**Operating Facilities**

**Assessment of EDF's graphite materials properties model in NP/SC 7766 V10 SS1  
(Operation of HNB R3 to a burn up of 16.425TWd) and implications for the predicted  
brick stresses, dimensions and overall damage tolerance assessment**

Assessment Report ONR-OFD-AR-19-093  
Revision 0  
29 July 2020

**Figure 12: Dependence of structural connectivity on fast neutron fluence, weight loss and irradiation temperature**

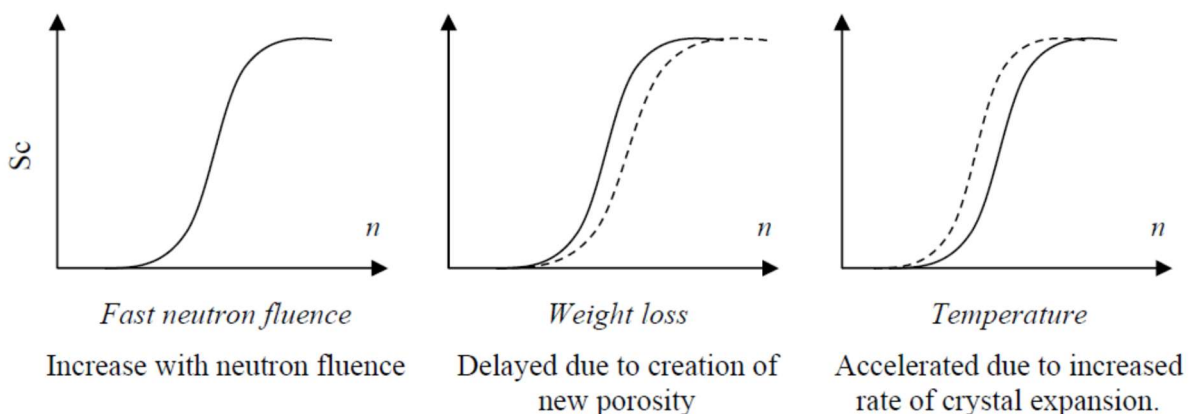
63. It is instructive to compare the shape of the  $Sc$  curves with the materials properties variation. Suitably scaled, such a term can help model for example, the rise in DYM (see Annex 1) that occurs in mid-life during the period of relevance to AGR operation.

Figure 18: Components of proposed irradiation creep expression. These are summed in order to obtain the predicted irradiation creep trend.

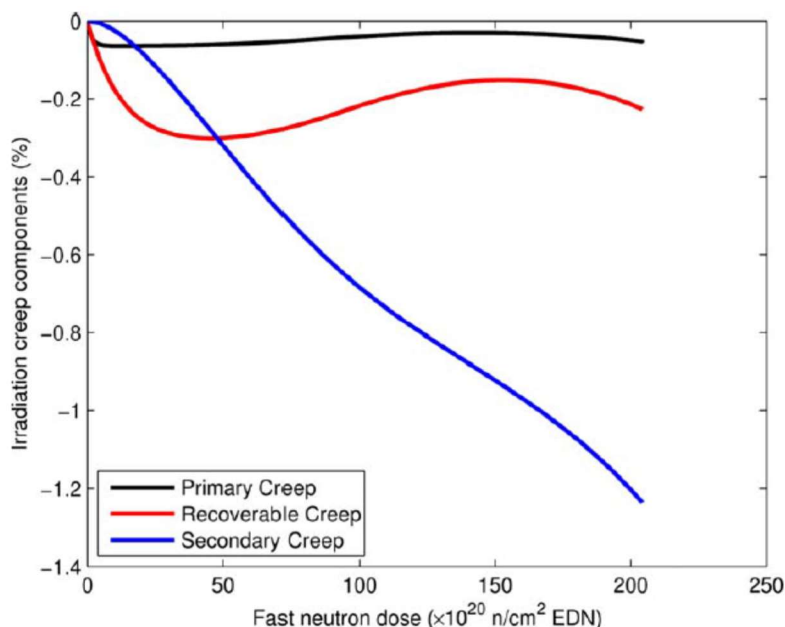
83. Within EIM1.1, CTE is considered to be dependent just on primary creep strain according to the equation below (equation 20 from Reference 11).

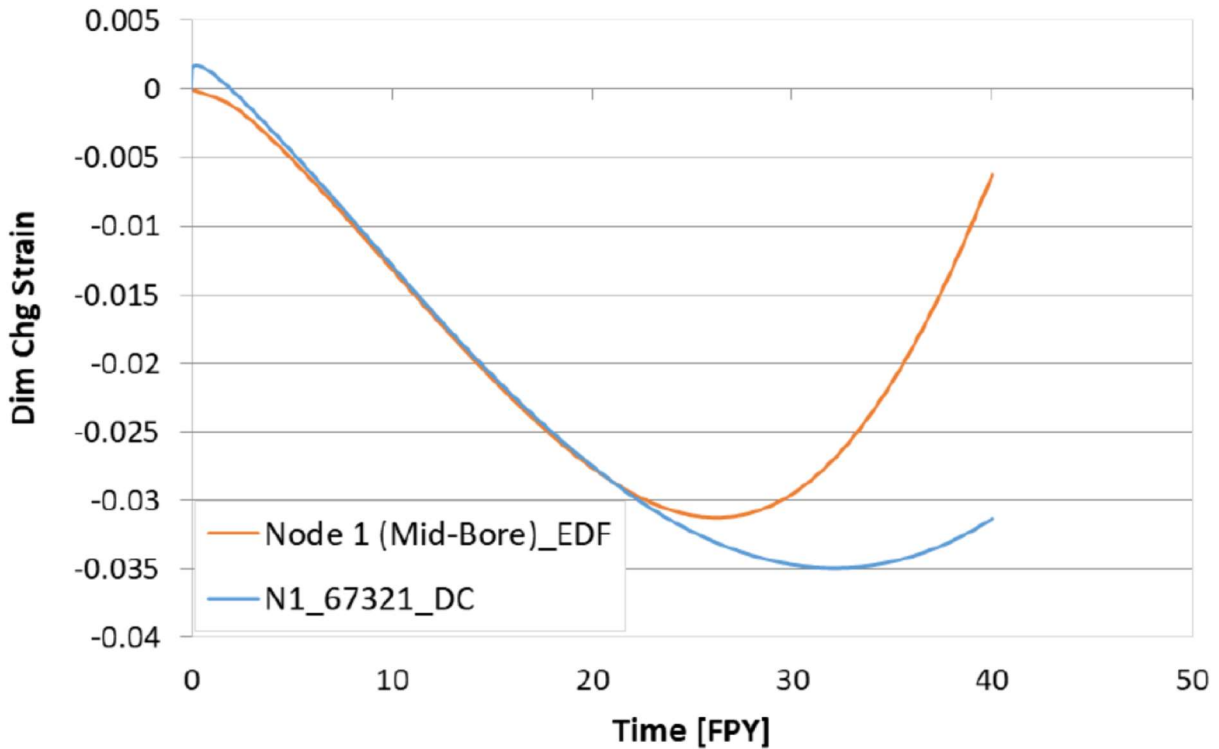
126. The features that can be noted from the comparison figure above are firstly that there is agreement over most of the pre-turnaround range and that secondly that there is a significant difference both in the point of turnaround and also the post turnaround gradient.

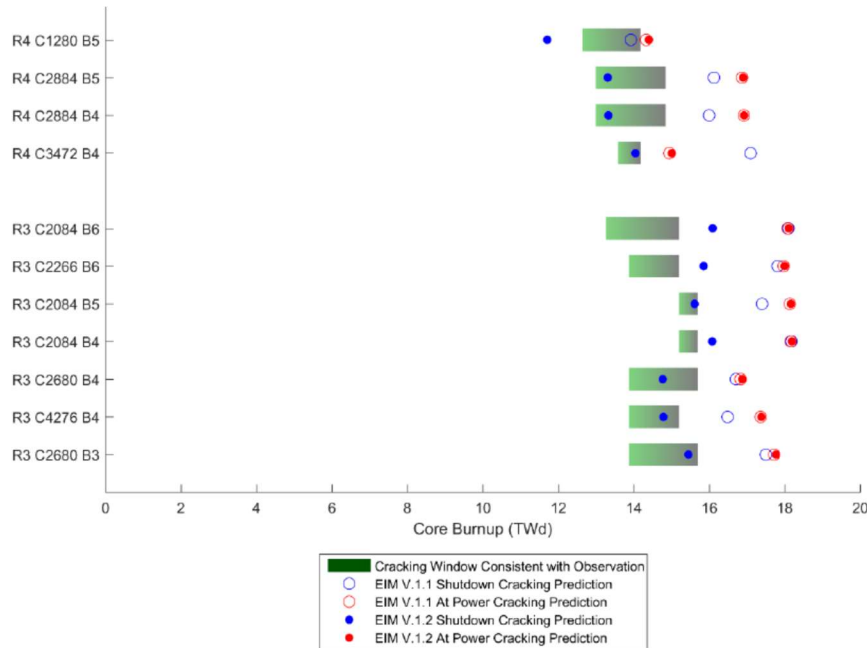
- 173. In Reference 38, an analysis of KRCs known of in HNB by 2017 in re-inspected channels is described, i.e. a total of 11 cracks. They use a brick specific analysis i.e. taking account of the layer and individual channel parameters. Using this technique a prediction is made using both EIM1.1 and 1.2 of the expected time of cracking. This is then compared with the observed ‘time window’ in which cracking could or would have occurred i.e. as set by the last inspection where the crack was not present and the first where it was. In the figure below i.e. figure 4 from Reference 38, the green bars represent the time window for cracking and the dots represent cracking at-power and at-shutdown predictions for both EIM1.1 and 1.2. It is noted that the at-power

predictions are very similar for both EIM1.1 and EIM1.2 and ahead of both of the shutdown predictions. The blue dots represent the EIM1.2 at-shutdown predictions. These are earlier than those for EIM1.1. Also 7 out of 11 of them overlap with the time window.

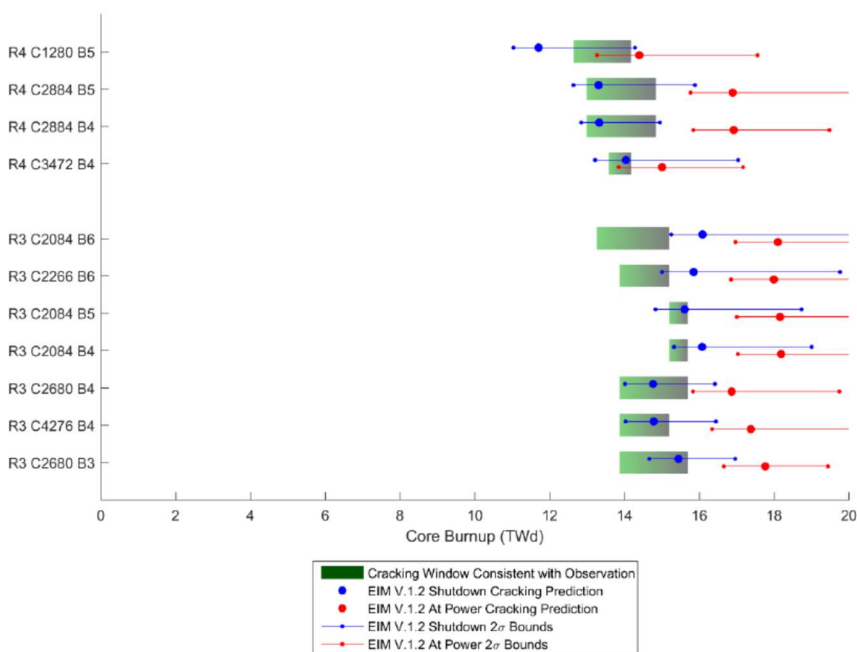
- 175. It can be seen from Figure 8 that the EIM1.2 cracking at-shutdown prediction overlaps in most cases with the observation window. The authors of Reference 38 comment that, with EIM1.2, overlap occurs for 10 out of 11 bricks, whereas with EIM1.1, overlap only occurs for 2 out of 11.
- 176. The authors of the GTAC Q62 report (Reference 22) note that the change from EIM1.1 to 1.2 produces a good agreement with the timing window, although caution that this may not be purely due to the change in the CTE/creep relationship, as updated calibrations and dosimetry changes are also involved.

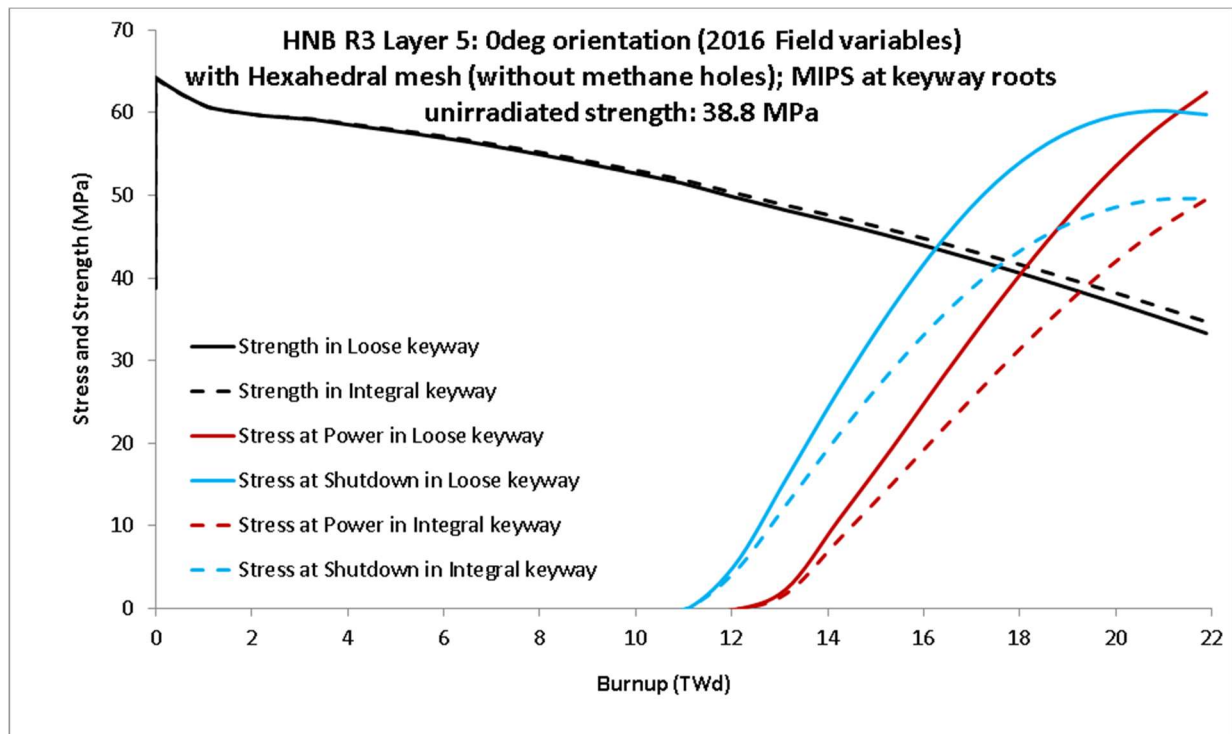
179. Using the UofM independent model (Reference 37), stresses were also predicted and are shown in the figure below. These were calculated using the field variables used for EIM1.1 and are therefore perhaps best compared with EIM1.1.

180. The stress predictions between the UofM and EIM1.1 model are comparable, although the stress at power appears slightly higher for the UofM model. Thus in the above figure, the stress at power in the more vulnerable loose keyway is approximately 28MPa at 16.425TWd. This can be compared with the figure in section 5.1, where the equivalent EIM1.1 stress is approximately 26MPa. This should not be seen as a complete validation of the EIM predictions as, for example, there are common field variables used, so any error in those calculations would carry through into the stress predictions. Nevertheless, the materials property models are significantly different and it is reassuring that the results are comparable.

**Figure 6: Predicted distortions of the loose bearing key and keyway at brick mid-height.**

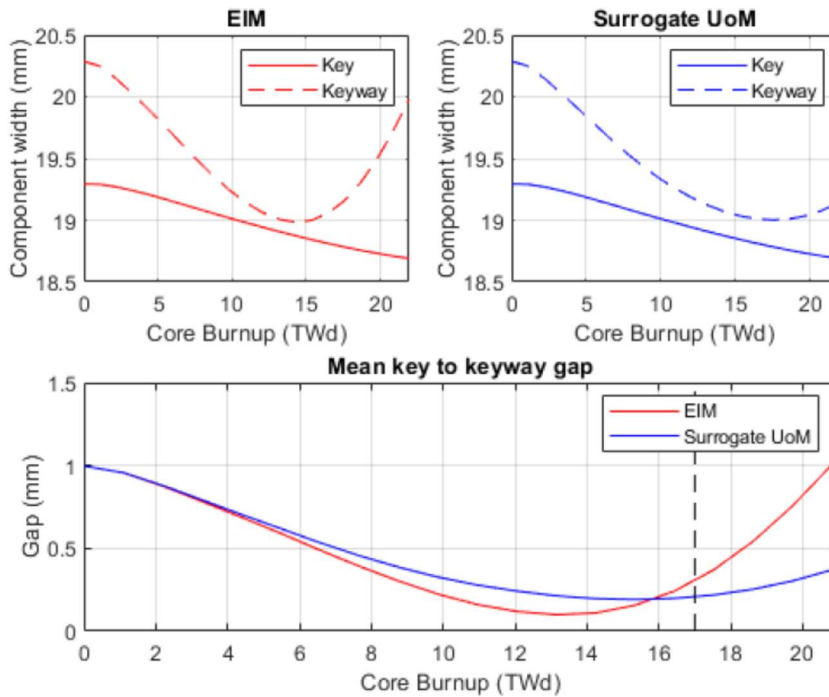
190. It can be seen that the mean key/keyway gap at 16.425TWd, slightly to the left of the dotted line would differ little between the models, perhaps by less than 200µm. This small value is reassuring in itself. However there is a caveat in that FNC have calculated a mean gap, not the minimum gap that is used in GCORE. The minimum gap decreased to zero as explained above and the behaviour thereafter may have been slightly different because of the pinching of the keys by the keyways and the associated constraint. FNC's finite element analysis program FEAT cannot address contact between surfaces and NGL normally uses a further stage of analysis performed elsewhere before determining the GCORE parameters.

201. I note though that this judgement does depend on the change in key/keyway gaps being limited. Reference to the figure above shows that the difference in gap is low at the limits of the safety case i.e. 16.425TWd, but is increasing thereafter. Therefore the conclusion I have reached above does not necessarily apply to future safety cases, which may require a more detailed analysis. As discussed above, I have made the need for further analysis for successor safety cases an additional recommendation.

## Illustrative Change in Clearances by Layer

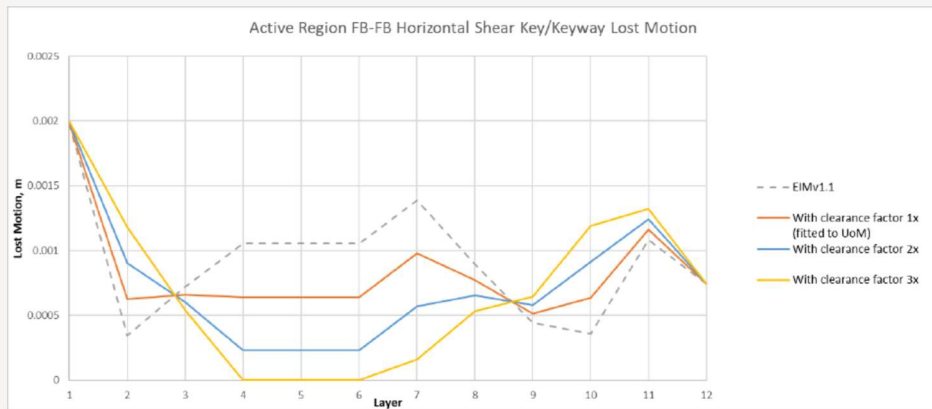
193. The 'lost motion', for the EIM is greater than the UofM prediction for layers 4 to 8, reflecting the higher fluence, whereas for the higher and lower layers it is similar or smaller. I discuss the implications of this below.
194. Four GCORE runs were performed, as described in the 'run log' table below. These are for EIM1.1 parameters, and UofM surrogate key/keyway gap values multiplied by 1, 2 and 3. In each case, the cracking state is stated at the 99.9% level i.e. allowing for uncertainty in the cracking predictions after a period of operation. Although the degree of cracking is less than the CEDTL, I consider that it is an adequate level for the purposes of a sensitivity study. The other two tables show the calculated interstitial channel distortion and the extent of keying system damage. All three tables are from the TQ G8 response.

Figure 10 – Integral and loose key/keyway utilisation histograms for most onerous runs from cracking conditions C and D.

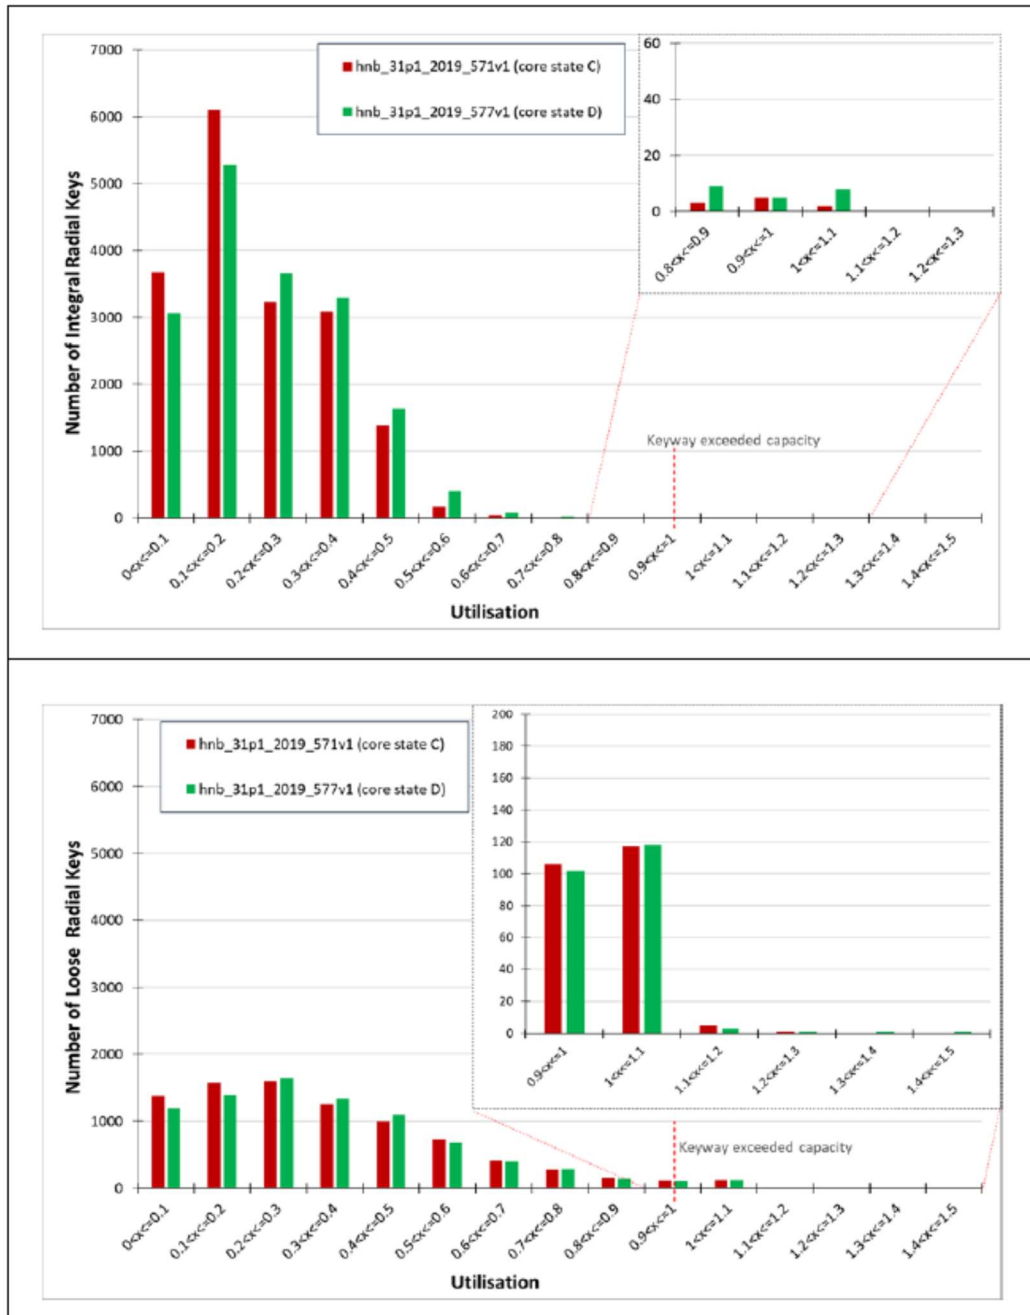
- 210. Whilst I acknowledge these conservatisms, it is not immediately obvious whether NGL has provided an adequate argument that a reduction in capacity of up to 20% will be sufficient allow for potential systematic errors in the materials properties calculated by the EIM and whether it significantly worsen the seismic margins.
- 211. It does appear to be the case that the extra key/keyways that would fail are limited to perhaps 200 loose keys and a few integral ones. The studies do not reveal how many extra axial/end-face keys might fail. I can though see that there are potential optimisms in the analysis, such the absence for allowance for the scaling of notch
